BID
ADDENDUM NO. 3
TO
CONTRACT DOCUMENTS
AND
TECHNICAL SPECIFICATIONS
FOR
2019 BOND REFERENDUM
CAPITAL IMPROVEMENTS
AT
MAMARONECK HIGH SCHOOL
PHASE 2
NYSED #66-07-01-03-0-001-039
BID # 20/21 – MUFSD-00

Mamaroneck Union Free School District
1000 West Boston Post Road
Mamaroneck, NY 10543

LAN Job #4.1092.72.06
January 7, 2022

OVERALL KEY PLANS
CAPITAL IMPROVEMENTS AT
MAMARONECK HIGH SCHOOL
MAMARONECK UNION FREE SCHOOL DISTRICT
1000 BOSTON POST ROAD, MAMARONECK, NY 10543

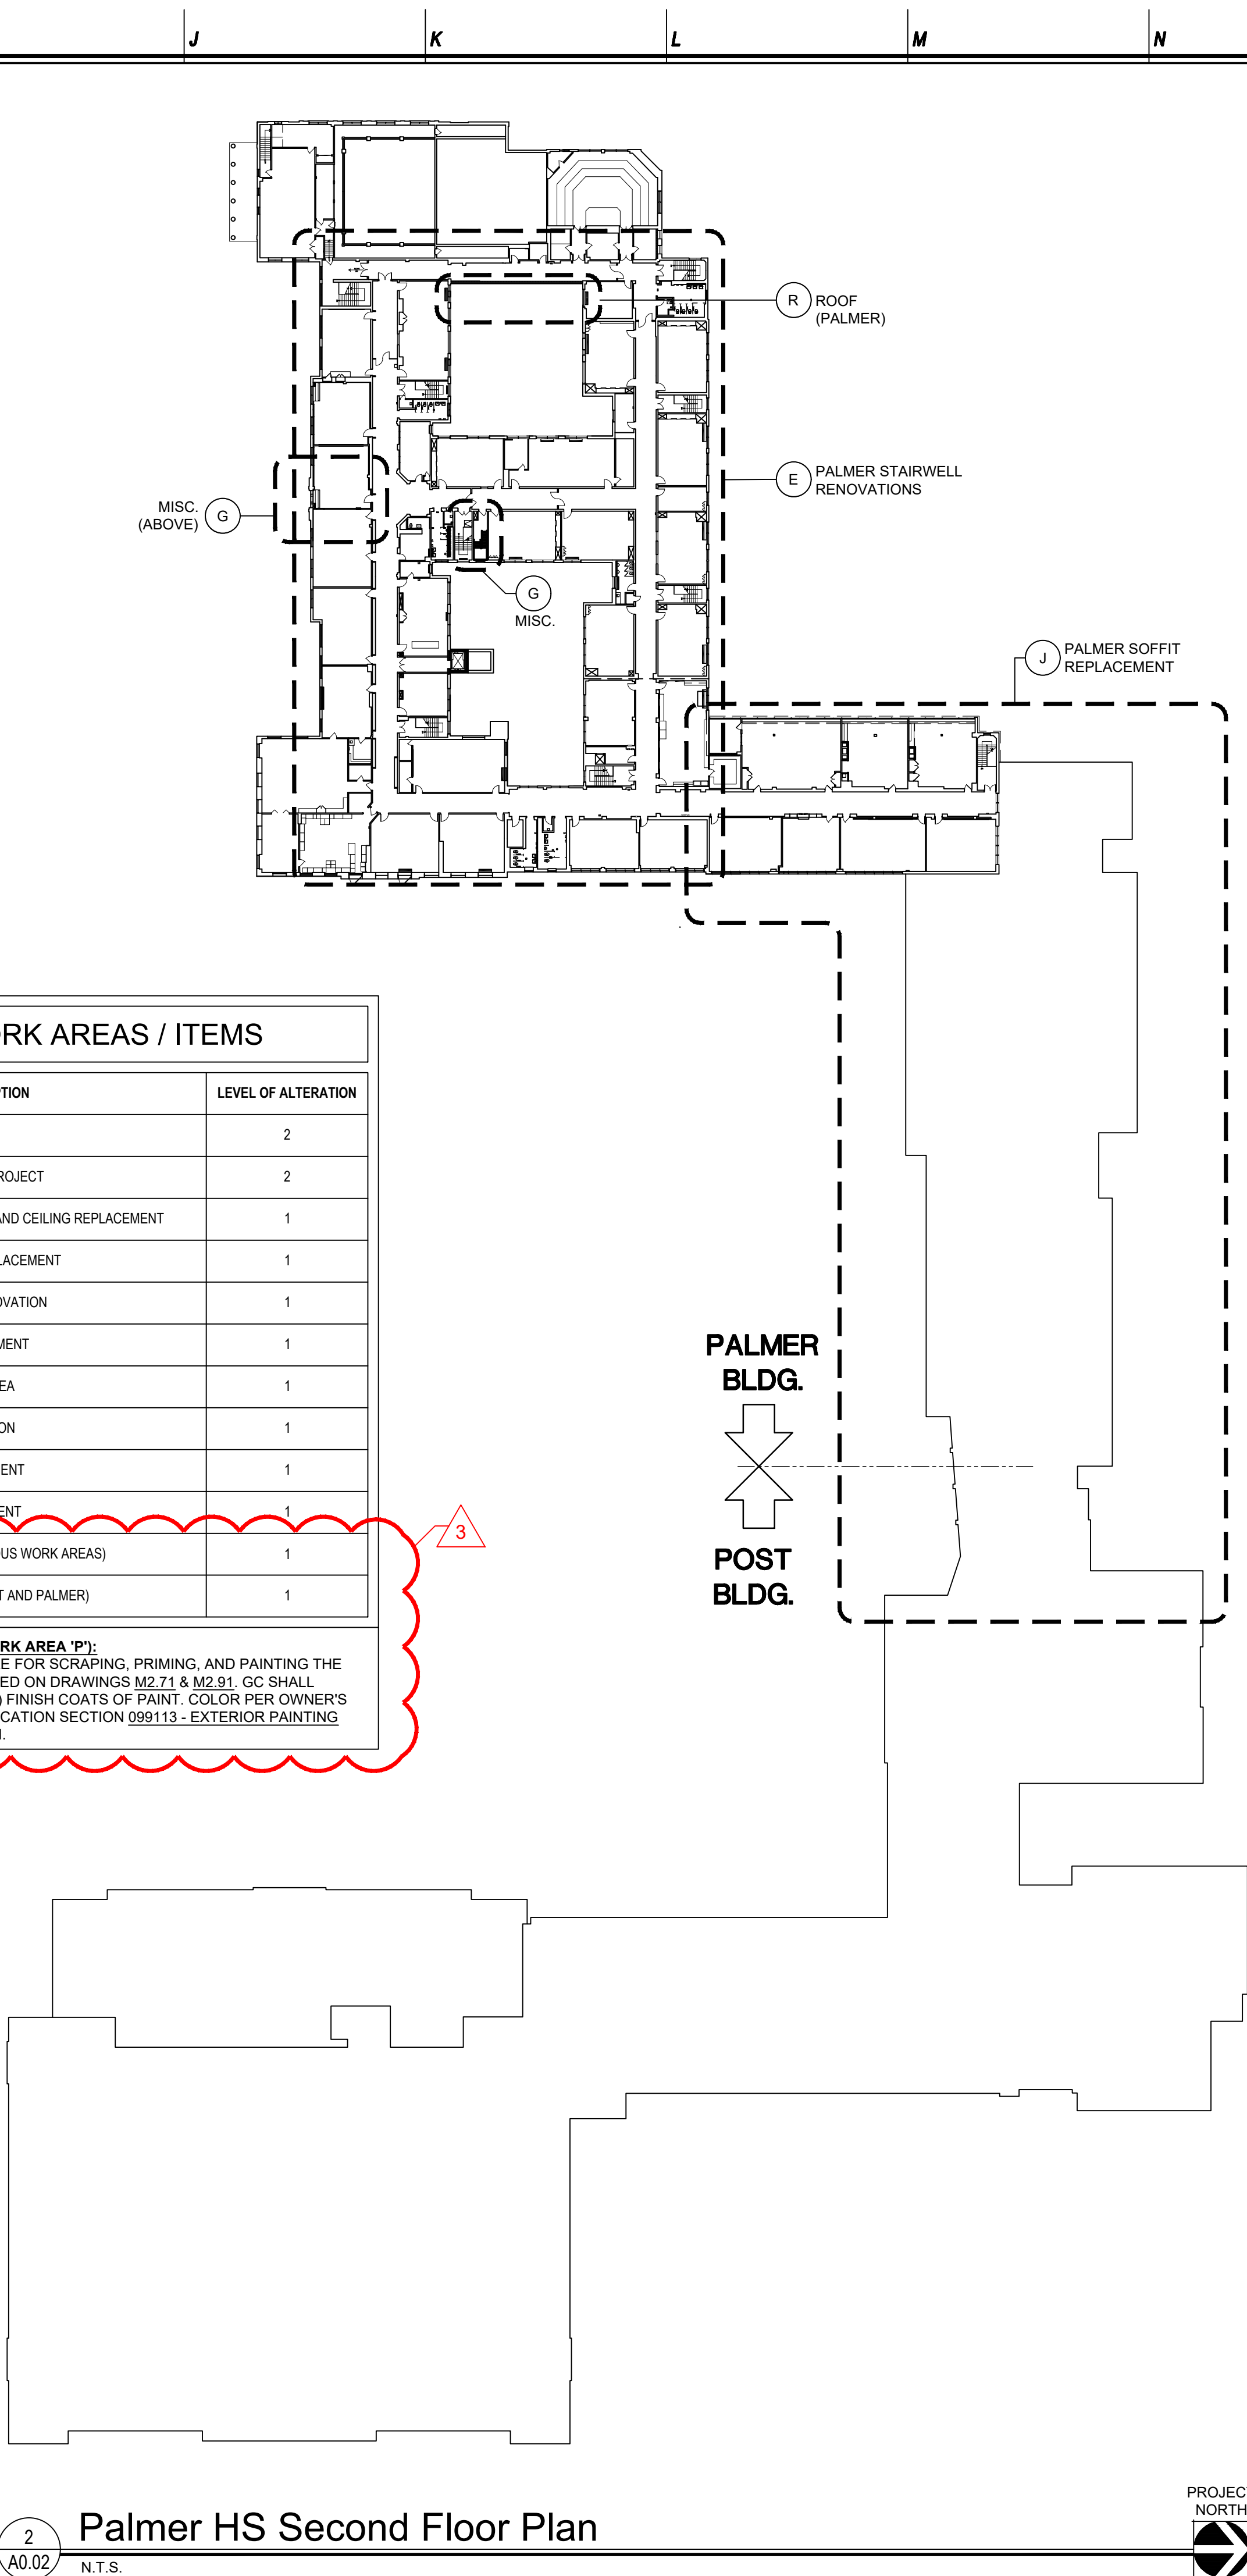
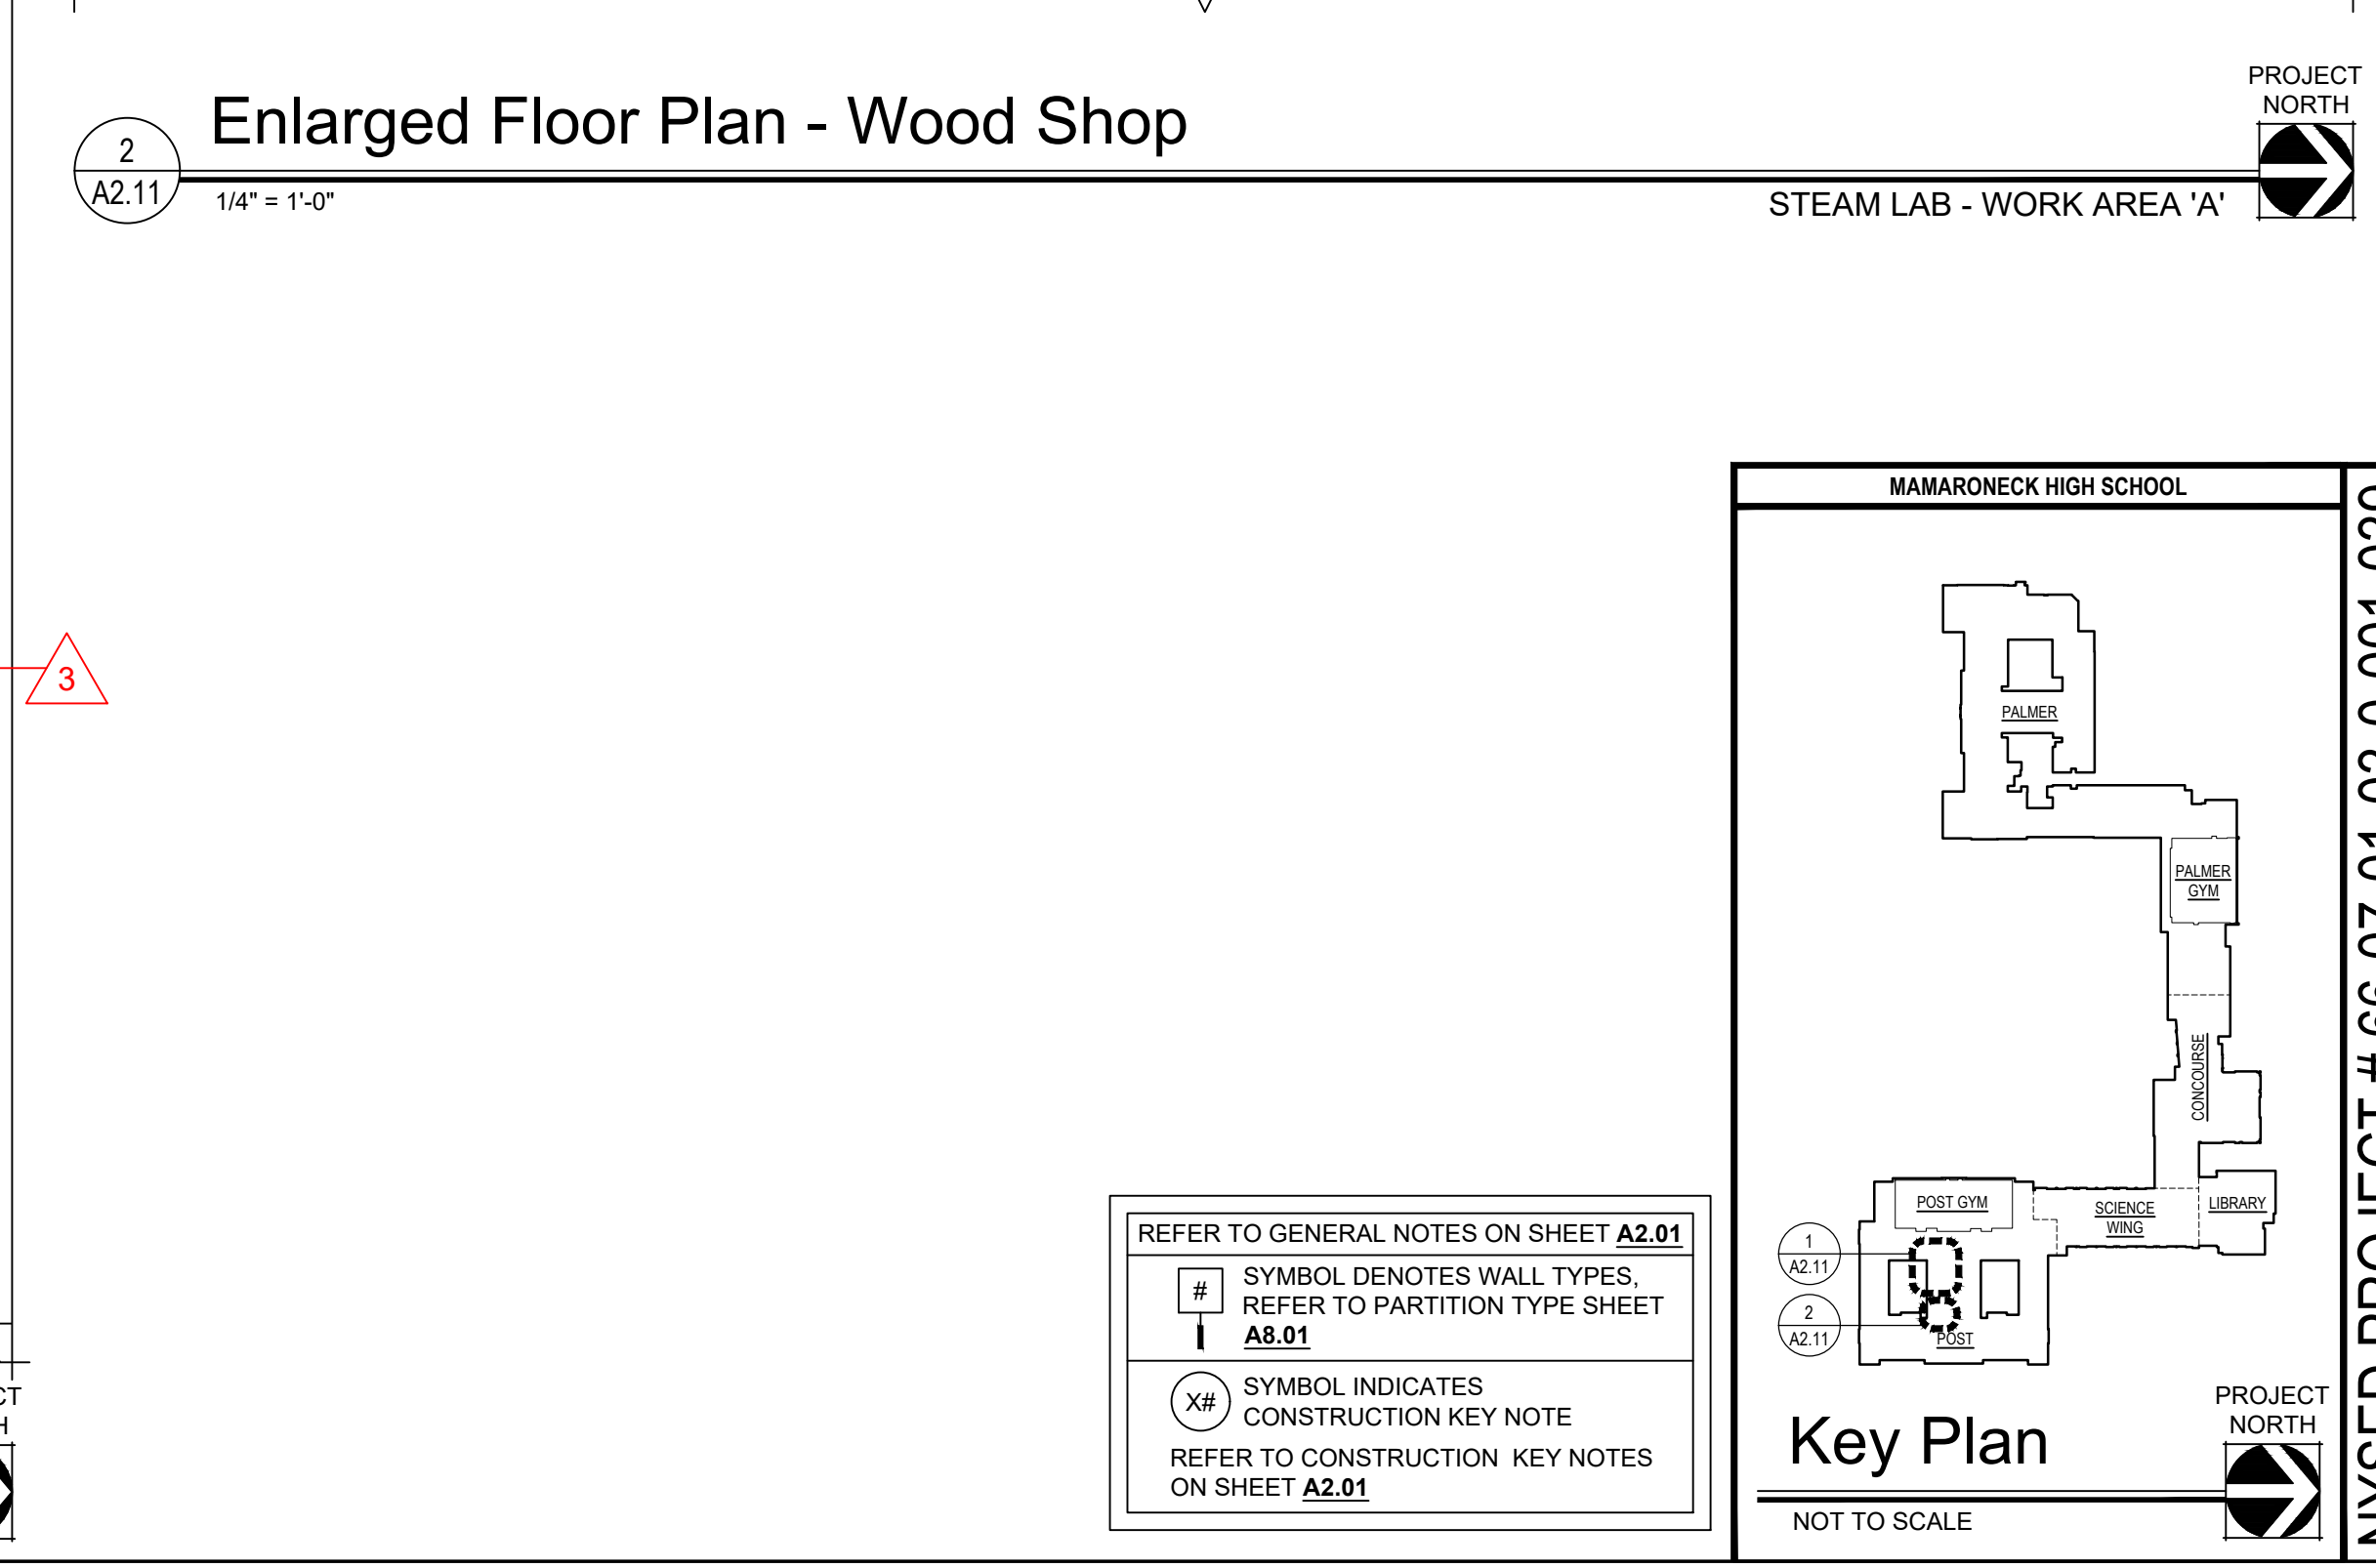
Drawing No.	Addendum Requirements
A0.01	Work Area 'P' – Dunnage Painting (Various Work Areas) has been added to the SCOPE OF WORK AREAS/ITEMS list as well as the Dunnage Painting Note below it.
A0.02	Work Area 'P' – Dunnage Painting (Various Work Areas) has been added to the SCOPE OF WORK AREAS/ITEMS list as well as the Dunnage Painting Note below it.
A2.01	Drawing updated to reflect convector covers to be painted by the GC.
A2.11	Drawing updated to reflect convector covers to be painted by the GC.

- 7 Question: As discussed in the walkthrough the Existing Dunnage Scraping and Painting is to be performed by the GC. After review of the following Contract Drawings, M2.71 includes the following note, "Insert Note GC to scrape and Paint Steel Dunnage" and in addition refer to M2.91, Demo and Construction Key Notes 1, 2 & 4. Please confirm if any portion of this work including Alternate 6B-2 is to be provided by the General Contractor.

- Response: Painting of the dunnage shall be by the GC. Refer to updated drawings A0.01, A0.02, M2.71, and M2.91.
- 8 Question: Please refer to Contract Drawing M2.11, FD/SD is indicated on the plan in several locations. Please refer to M0.01 where FD/AD and FSD/AD symbols are indicated. Please clarify the desired assembly to be provided on M2.11.

DUNNAGE PAINTING NOTE (WORK AREA "P"):
 THE GC SHALL BE RESPONSIBLE FOR SCRAPING, PRIMING, AND PAINTING THE EXISTING DUNNAGE AS OUTLINED ON DRAWINGS M2.71 & M2.91. GC SHALL PROVIDE (1) PRIMER COAT & (2) FINISH COATS OF PAINT. COLOR PER OWNER'S SELECTION. REFER TO SPECIFICATION SECTION 099113 - EXTERIOR PAINTING FOR ADDITIONAL INFORMATION.
